A G E N D A

Architectural Review Board

September 27, 2016

Fiberglass Column
 Detail

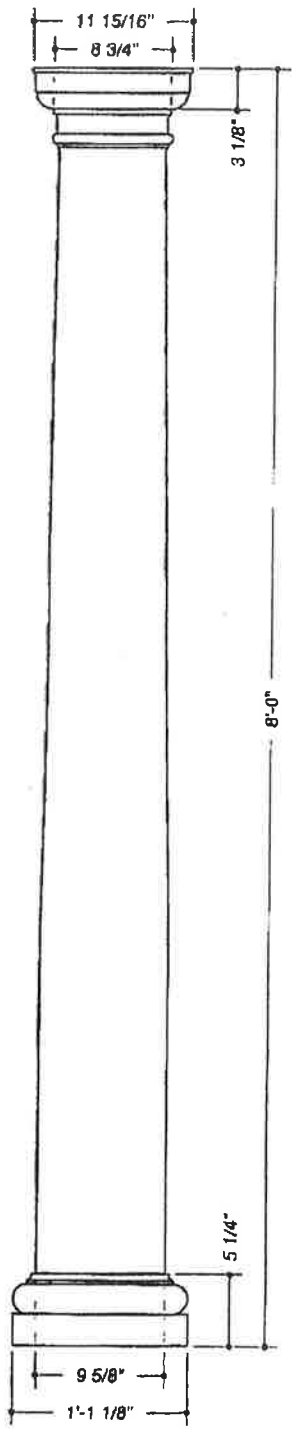
REMARKS: The petitioner is requesting permission to replace the existing wood front porch columns with a cast fiberglass column that is similar in detail and dimensions. The current columns are rotten at the base and have several repairs made over the years, the trustees would like the fiberglass option available, but are also exploring wood columns that match.

- We discussed the issues of authenticity and longevity on site, given the significance of the resource. They have been advised care should be taken with introducing an impermeable column (fiberglass) against the wood railing.
- The Board has previously approved fiberglass columns.

Proposed New
Rolling Steel
Door on Back
of Building

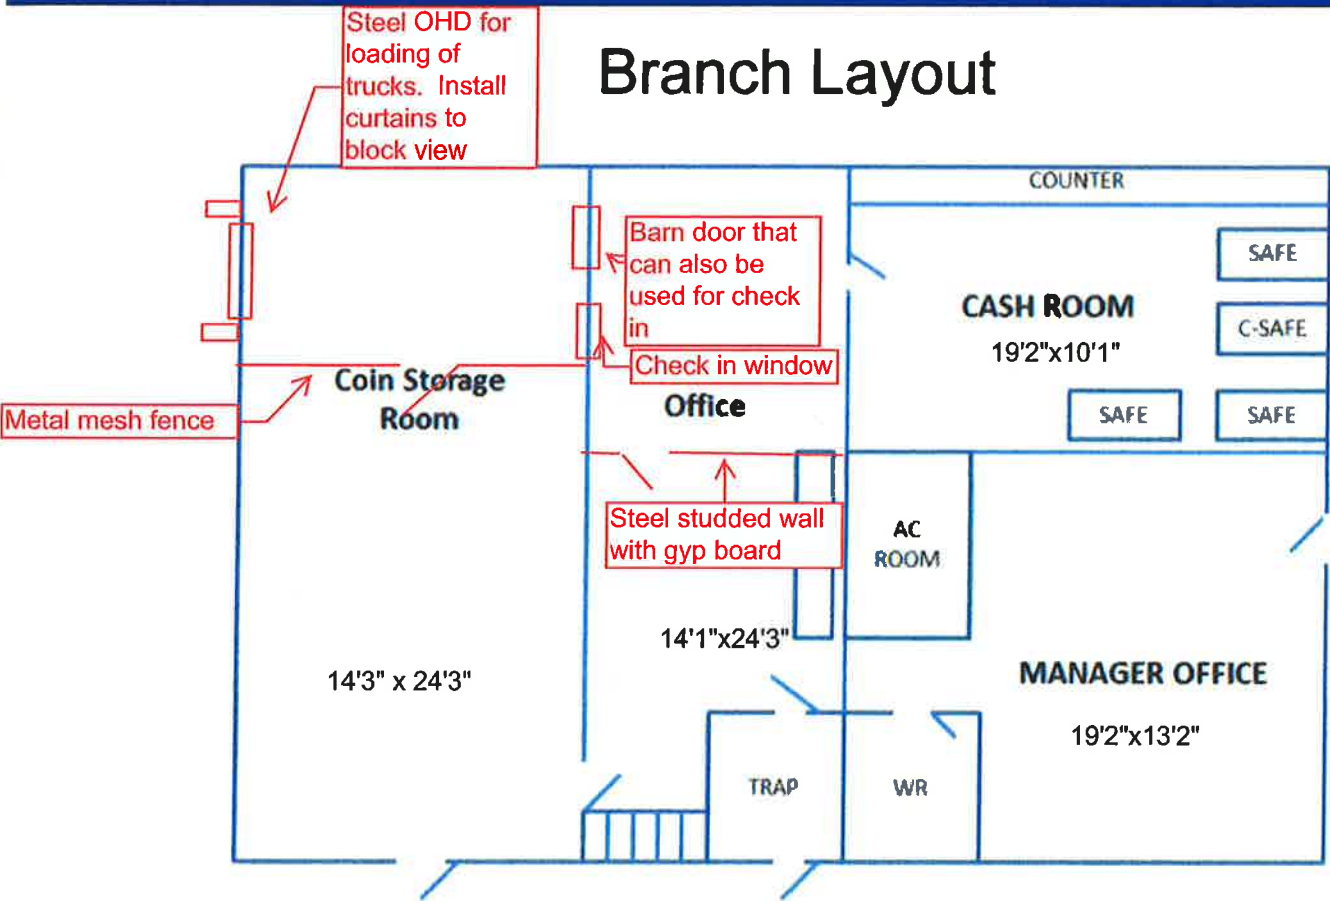
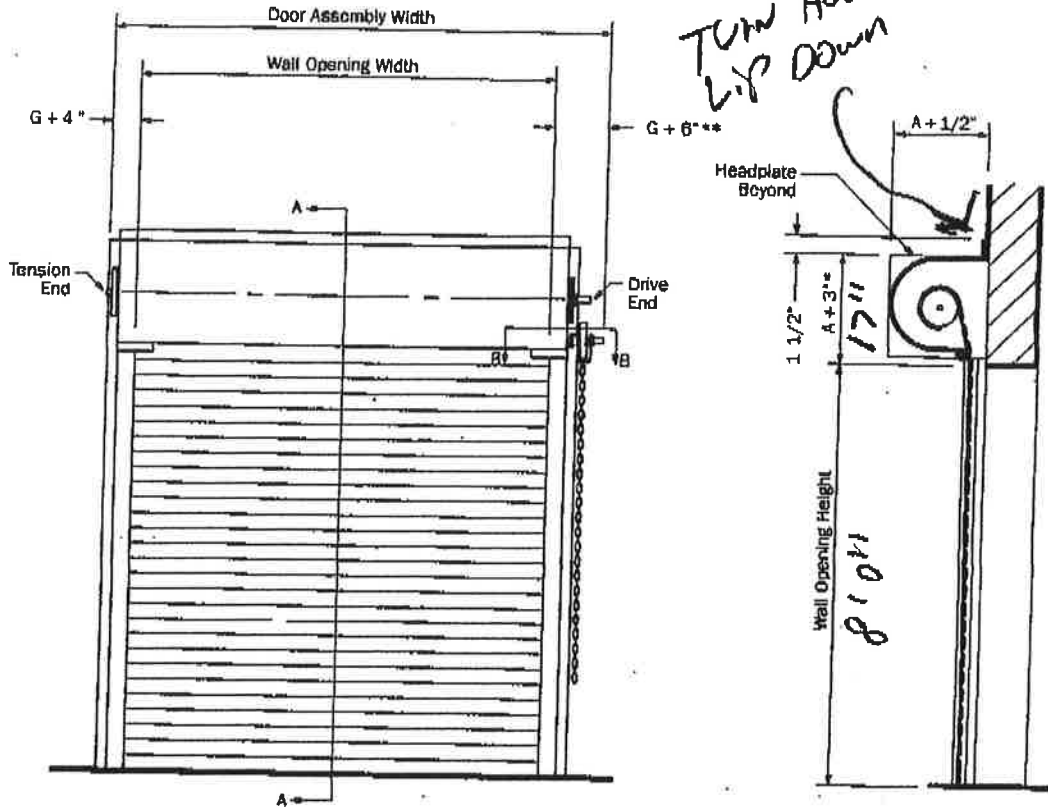
REMARKS: The petitioner is requesting permission to create a new opening on the rear of the structure that is 9'4" wide and 8' tall with a metal roll up door that will either retain a galvanized finish or be painted to match the building.

- This is a utilitarian building, and a rear facing door will not be visible from the street. The property to the rear of this building is not within the boundaries of a historic district.

80 Commerce Street

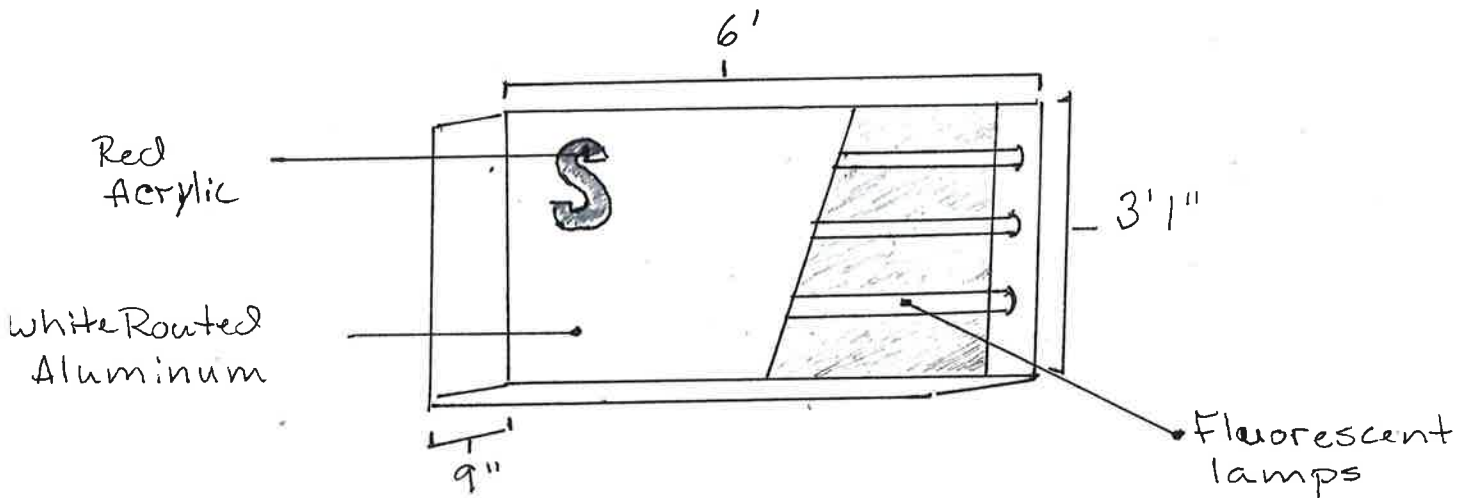
REMARKS: The petitioner is requesting permission to install a solid cabinet sign with incised letters that will be red and internally illuminated. The sign will be 3'1" tall and 6' wide, installed in the location indicated over the entry doors.

- The Board has approved similar cabinet signs elsewhere in the district: SaZa's & Wasabi
- The sign face area is less than the 20 square feet recommended in the design guidelines. The Board may consider if the scale and placement is appropriate for this building.
- The size of the sign is within the T5 Smart Code parameters, Smart Code does not allow internally lit signs outright.

102 North Lewis Street

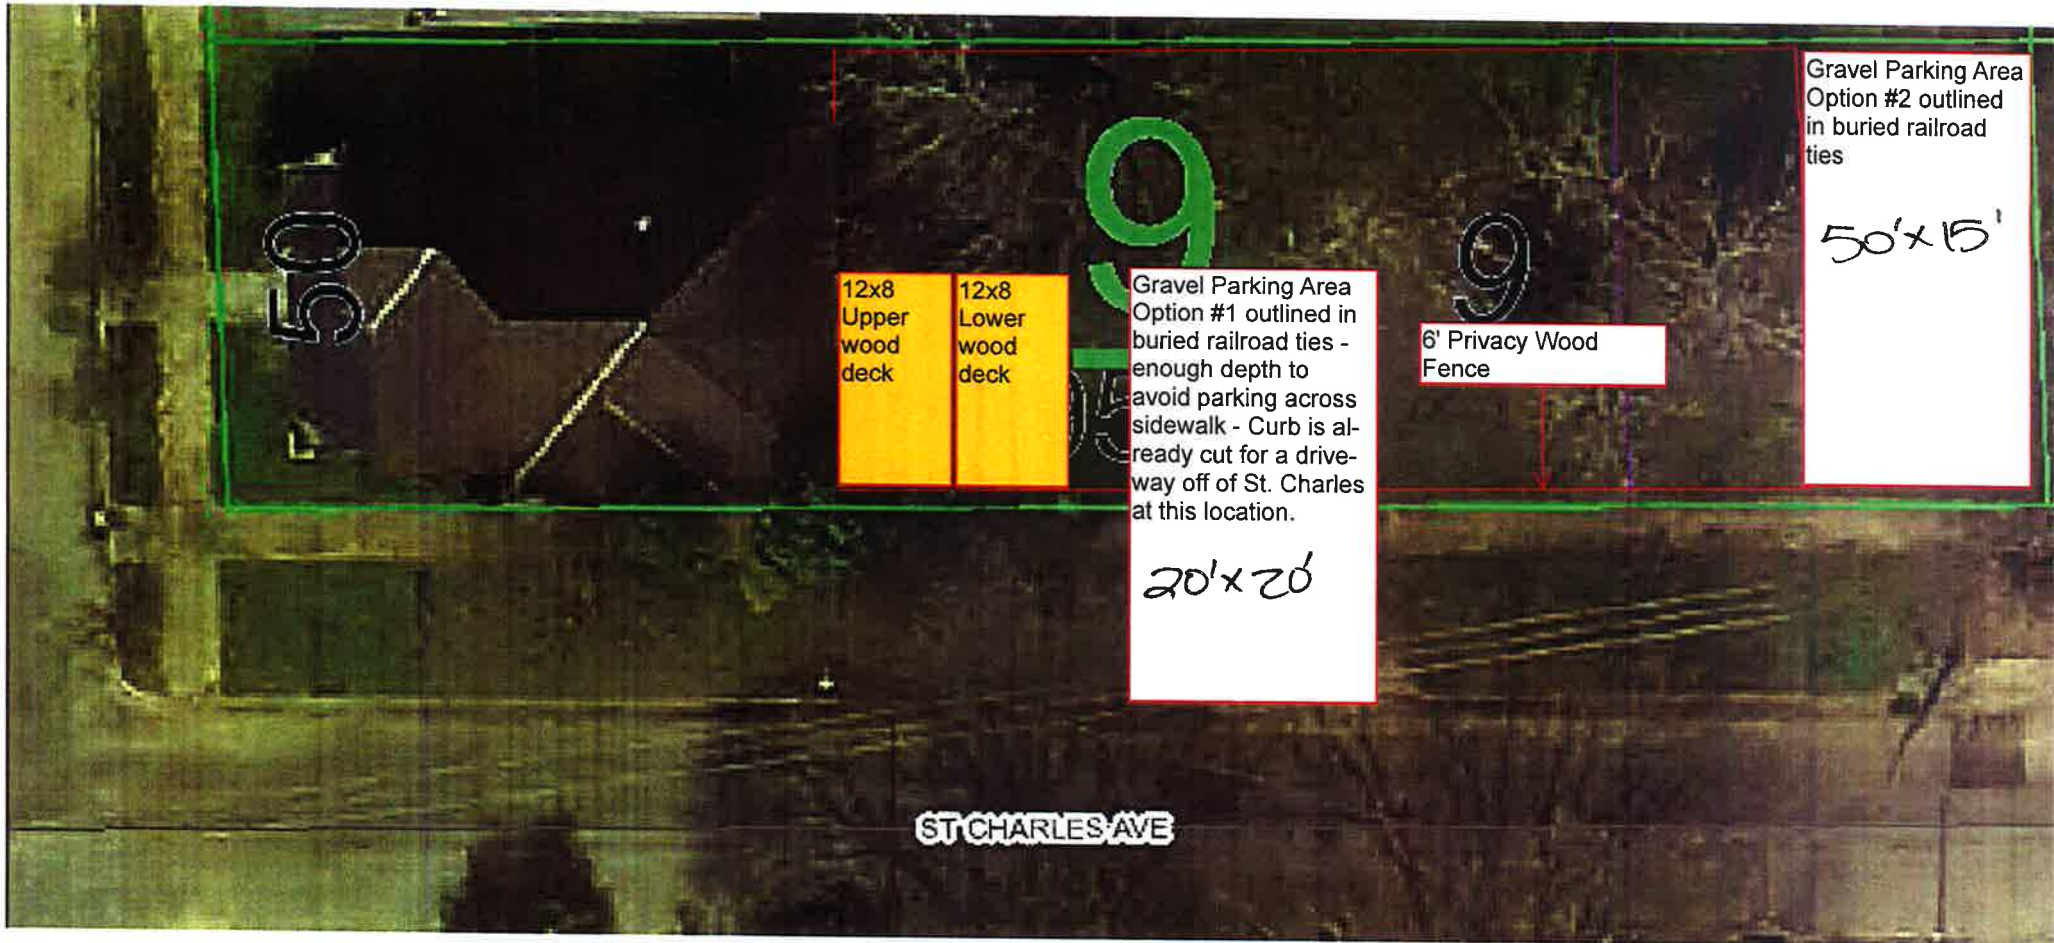
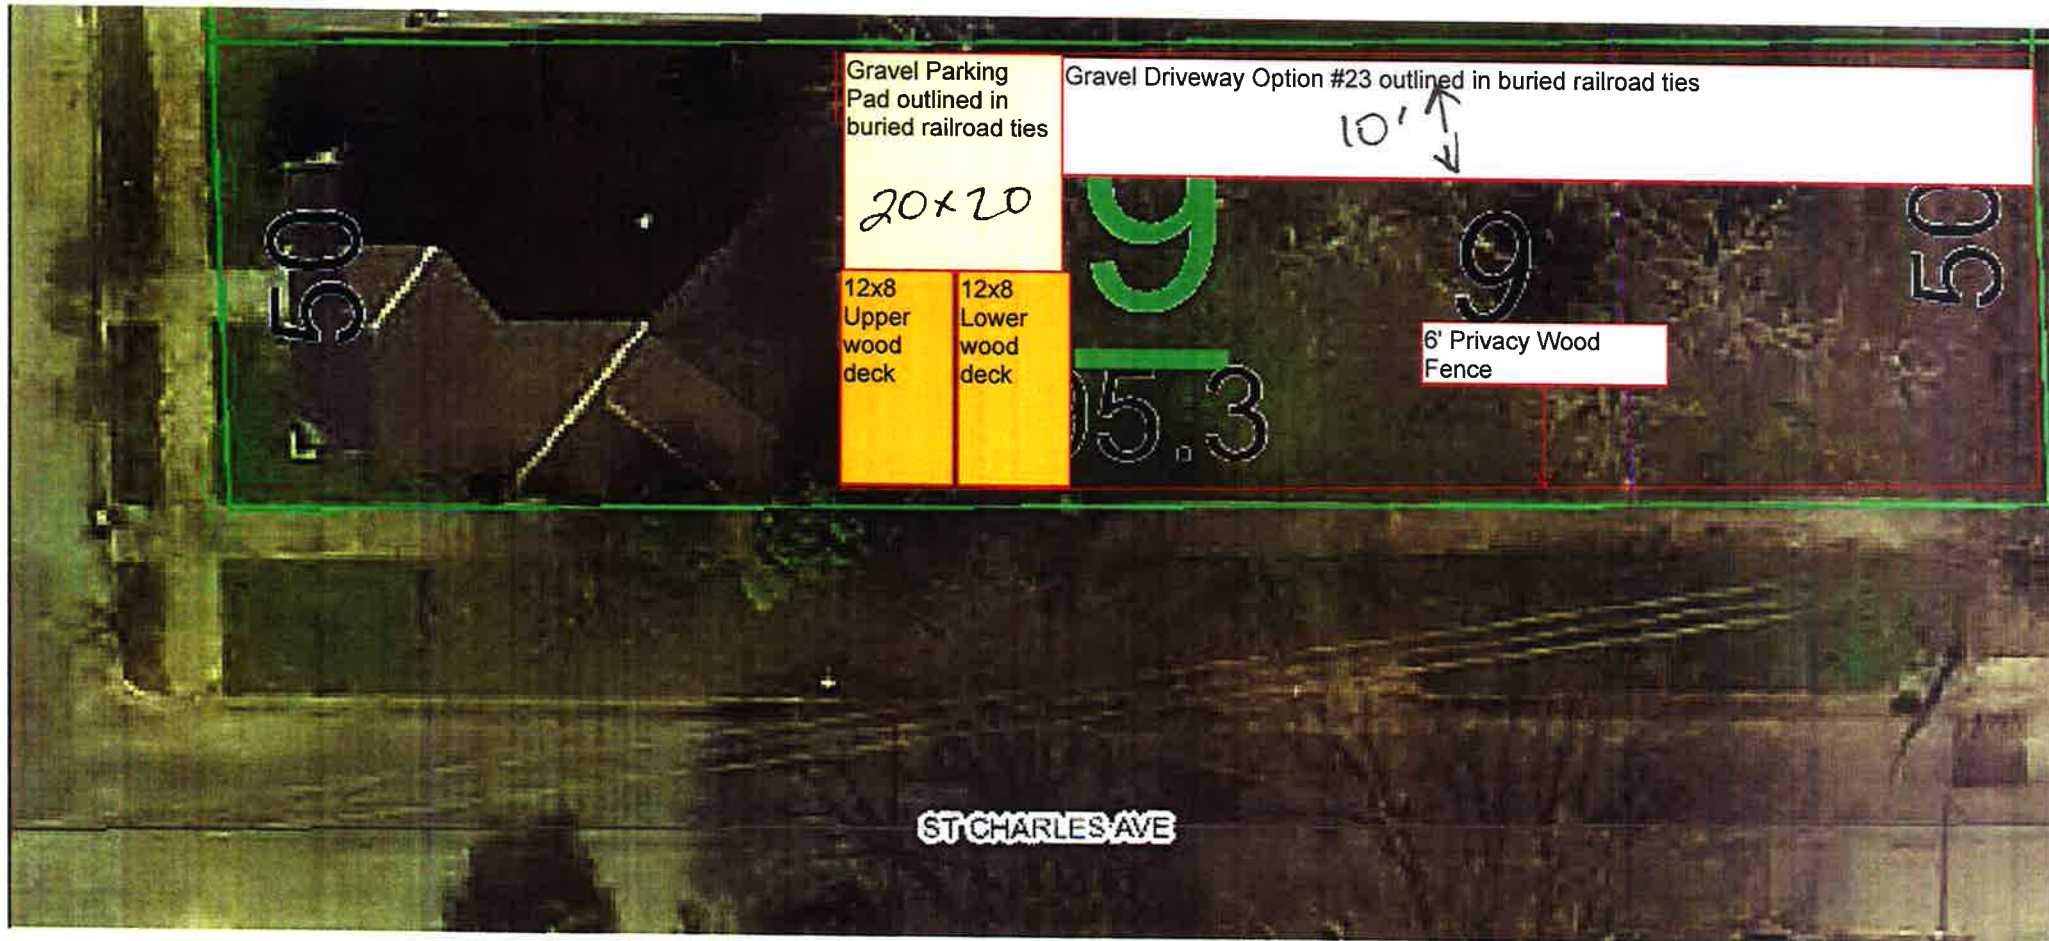
REMARKS: The petitioner is requesting permission to install a new porch railing, which will match the railing on the property next door (see photo) with the top of the handrail installed at 26” to fit under the concrete plinths; install a two tiered rear deck, with each tier 12’x8’ in the style illustrated; a 6’ dog eared paneled privacy fence to run in line with the house along St. Charles Avenue and then along the property line to enclose the rear yard (with gates to match); and 3 options for rear parking accessible from St. Charles Avenue, as illustrated. Parking areas and driveway would be gravel, contained and bordered by buried railroad ties.

- Rear deck will be largely screened by the installation of the fence. The Board has not required screening for rear decks on corner lots previously.
